# WDEP Shared Governance Committee Final Report

CLIMATE ACTION SHARED GOVERNANCE COMMITTEE

## Executive Summary

**Figure 1:** Campus Steam Load Profile from Consultant Model

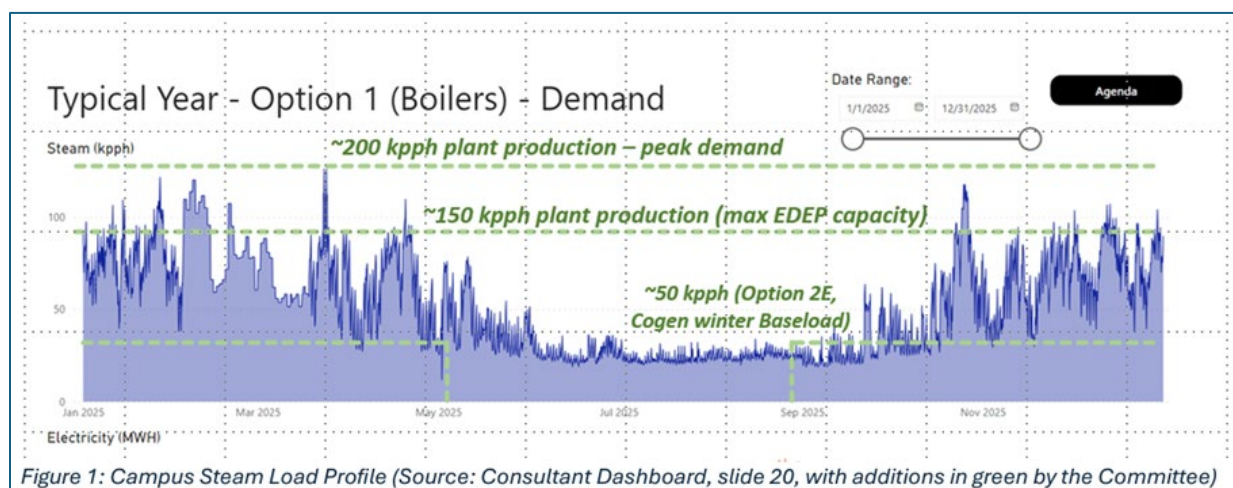
*Note accompanying Figure 1 in the Preliminary Report: The Committee's understanding of plant-side load is based on a scaling of the building model to peak demand reported from the plant. As discussed below, the Committee would be interested in reviewing plant side data*

- First, the University has not provided any documentation to back up its claim for 200 kpph peak Winter demand. The figures presented to the Committee by the University used a building-demand model developed by the University’s consultant. That model demonstrated peak demand of only 126 kpph (Mar. 25, 2025).<sup>11</sup> The Committee recognized that due to transmission losses, building demand (the model figure) is lower than peak generation required at the plant, which is the relevant figure for resilience analysis. However, the University has never presented the Committee with any documentation regarding its claim for plant-side peak demand of 200 kpph. The Committee flagged the lack of documentation in its Preliminary Report (p. 18) and made a formal request for documentation. See WDEP Shared Governance Committee, Additional Questions, p. 1 ([here](#)). The University did not respond to that or future requests.

- The University’s failure to provide the necessary figures and documents is of special significance because the firm capacity gap the University claims is quite small relative to peak demand (only 7%, i.e., 14 kpph out of 200 kpph).

**Figure 2:** Xcel Emission Forecast Relative to City of Boulder Benchmarks<sup>23</sup>

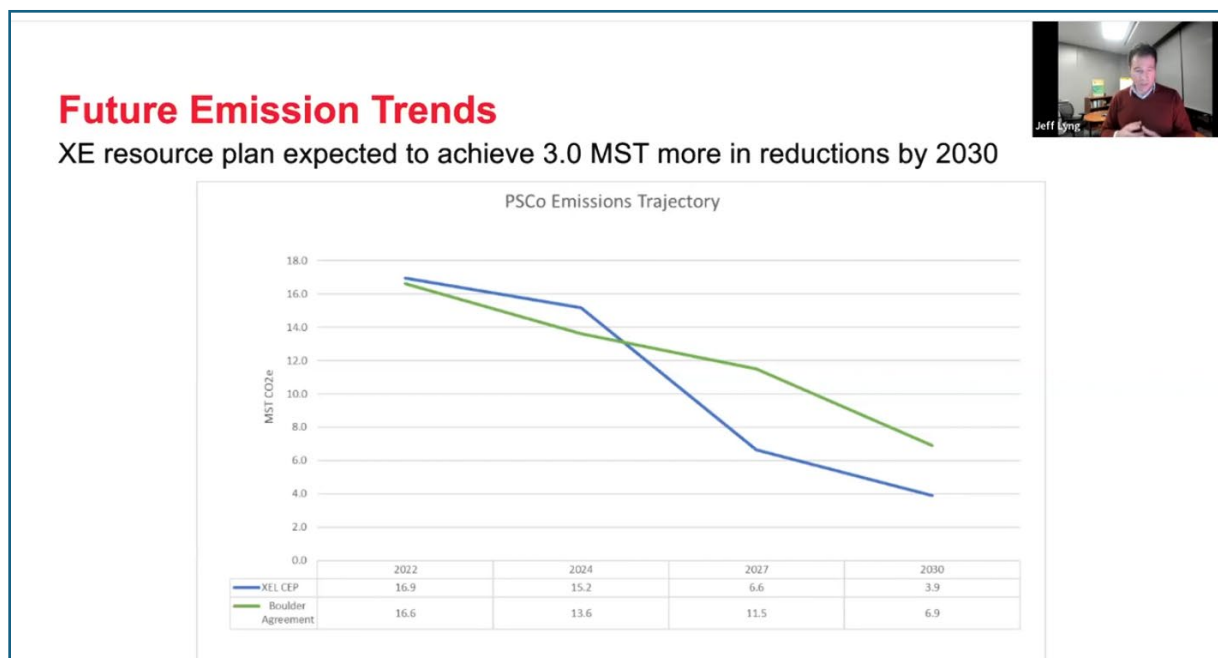
The statement conflates Xcel's climate targets under its Clean Energy Plan and separate targets under its agreement with the City of Boulder. It implies that Xcel's miss of the 2024 benchmark in the agreement with the City of Boulder is a warning that it will fail its 2030 Clean Energy Plan target (thereby delaying the year where Option 2E leads to excess emissions).

While the University is correct to note that Xcel missed its 2024 City of Boulder benchmark, that miss is not indicative of Xcel’s inability to meet its statutory 2030 target. Utilities’ progress towards targets is not linear, especially over short horizons. Meanwhile, the University seemingly missed encouraging indications regarding Xcel’s progress. Earlier this year (2024), Xcel provided a forecast indicating that it will significantly outperform the 2027 City of Boulder benchmark, as well as its statutory 2030 Clean Energy Plan target (see [here](#), around 40:00). That recent Xcel forecast is of special significance because it incorporates the Colorado PUC’s approval of Phase II of Xcel’s Clean Energy Plan (that plan approves new renewable capacity). Xcel’s forecasts translate to achieving 80% emissions reduction target as early as 2027 (3 years ahead of the 2030 target), and nearly 90% reduction by 2030.<sup>22</sup> A screenshot of the forecast is included as Figure 2 below. The green line represents the Boulder agreement benchmarks, and the blue line represents Xcel’s performance (including 2027 and 2030 forecast). The large area where the blue is below the green line represents the forecast for target overperformance by Xcel.

**Figure 4:** The University's LCCA for Option 1 and Option 2E (2025-2055)

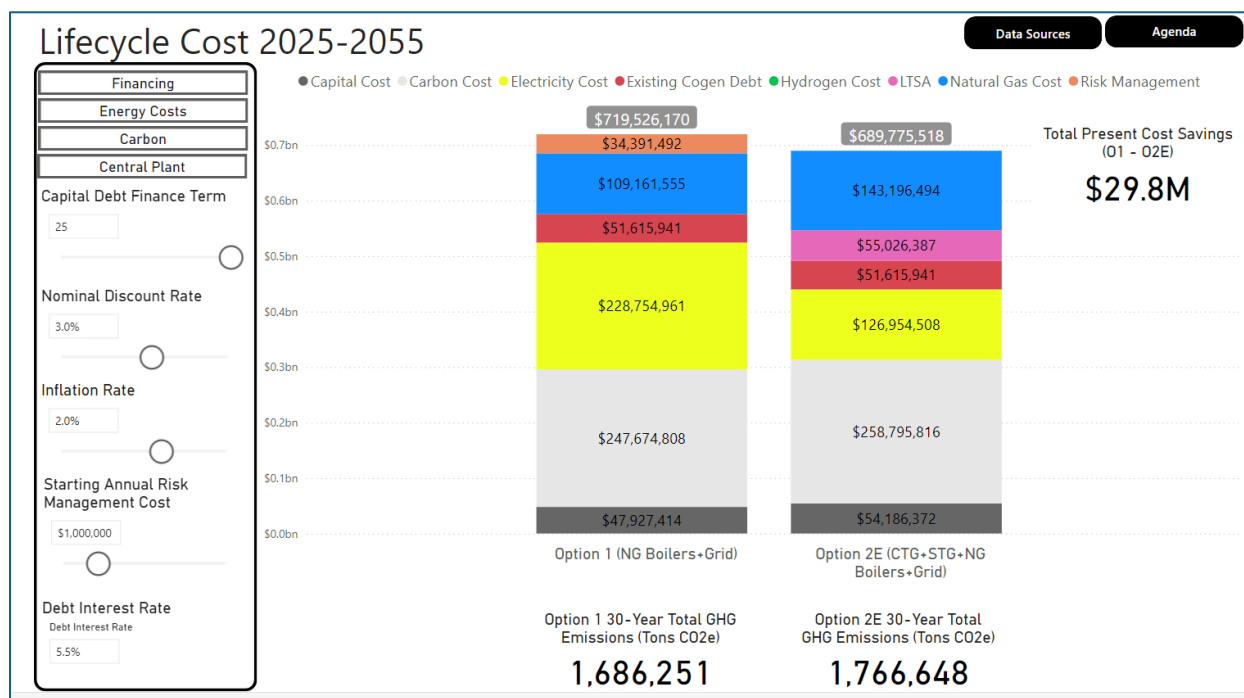
One key concern highlighted in the Committee's Preliminary report was the use of contradictory assumptions regarding baseloading of the new turbines under Option 2E (see discussion in Section B.2. above). From an emissions standpoint, the University claims that it will phase-out its use of cogen for baseloading to limit the increase in emissions of Option 2E relative to BAU. Meanwhile, from a financial standpoint, the University's analysis of Option 2E runs until 2055 (see screenshot below).

These contradictory assumptions are problematic because the savings in lifecycle cost identified in the consultant's model derived precisely from the operation of the cogen (and corresponding savings in Xcel utility bills). Graphically, this can be seen in the fact that the yellow and blue boxes (electricity and gas cost respectively) are higher for Option 1 (and hence, 1A) than they are for Option 2E (about \$337 million to \$269 million, i.e., \$68 million difference). The University faces a tradeoff between increasing its emissions and trying to reduce its utility bill. As discussed in the Preliminary Report (p. 1), Under the University's Energy Master Plan ("EMP", 2021), the University intended to refrain from baseloaded cogeneration once the emissions factor of the grid and boiler heat is lower than cogeneration. According to the University's own model, that point is expected to be reached as early as 2029. The only lifecycle cost advantages that Option 2E can have after 2029 are a direct result of departing from the EMP and increasing emissions relative to BAU. Thus, if the University abided by the EMP, there should be no meaningful lifecycle cost advantage to Option 2E after 2029. The Committee finds that the lower upfront cost of Option A1 (especially when considering uncertainty over the tax credit) would likely lead to an overall lifecycle cost for Option A1 that is similar or lower than Option 2E.

**Figure 5:** The University's LCCA for Option 1 and Option 2E (2025-2045)

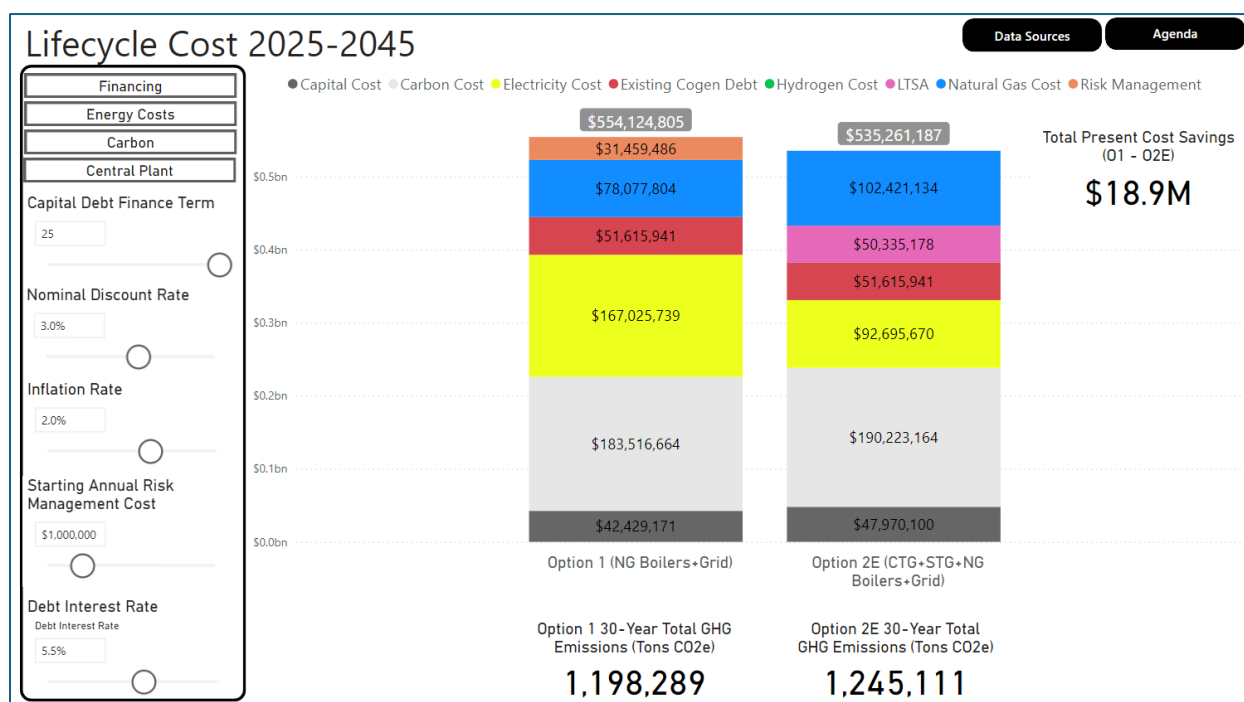
The consultant also performed a 20-year lifecycle cost-analysis for 2025-2045. This analysis found a smaller cost advantage to Option 2E over option A1, only \$19 million rather than \$30 million. Consistent with the Committee's analysis, the 2025-2045 analysis has a smaller utility bill difference: electric and natural gas cost (sum of yellow and blue boxes) equals \$245 million for Option 1 and \$194 million for Option 2E. That \$51 million cost difference (2025-2045 analysis) is \$17 million smaller than the \$68 million difference in the 2025-2055 analysis. That \$17 million amount accounts for nearly the entire difference between the shorter-term and longer-term analysis (\$19 million). Using the same logic, if the University chose to phase-out the baseloading of cogen prior to 2045, it would reduce the cost saving it claims even further.
